RE: 2018 NC Residential Code Section AM108.1 Post height and Table AM108.1 Deck Support Post Height

This letter is in response to your request for formal interpretation dated September 15 that was received in NCDOT by email on September 15, 2022. Your request for formal interpretation states in part:

Bonoff Residence
 4312 Cranes Bill Court
 Wilmington, North Carolina

LEFT SIDE ELEVATION SCALE: 1/4" = 1'-0"

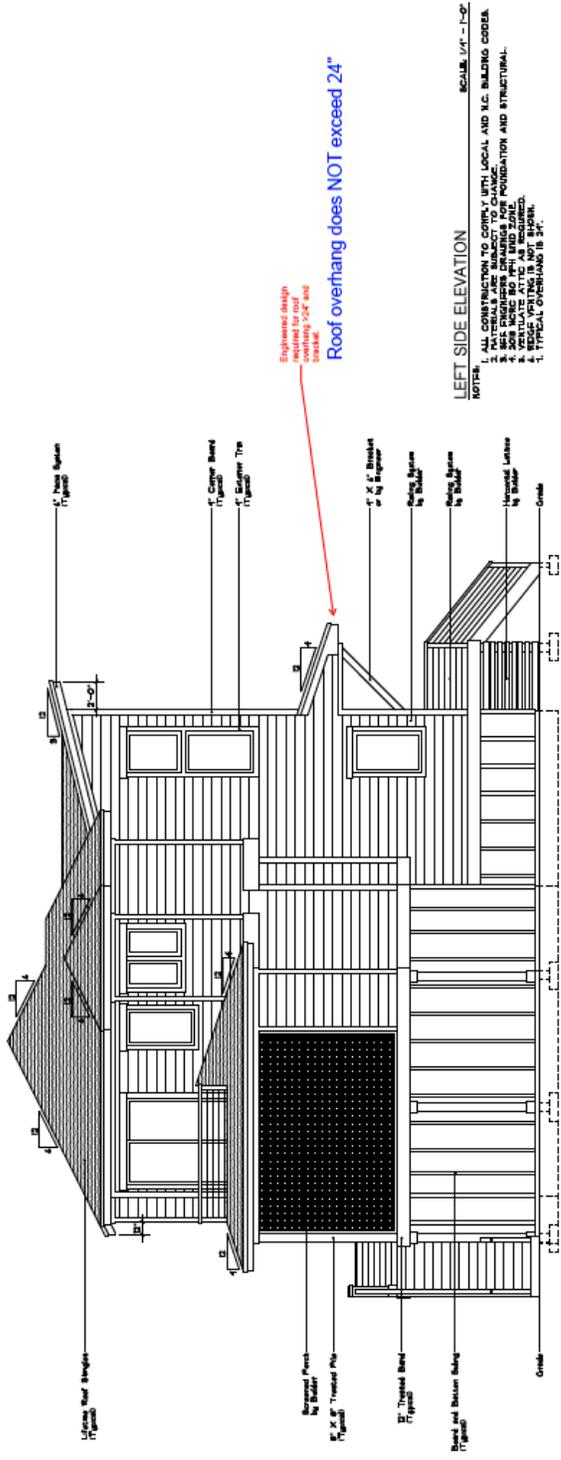
Engineered design required for roof overhangs greater than 24\"/>

Where is roof tie down to posts??

Roof overhang does NOT exceed 24\"/>
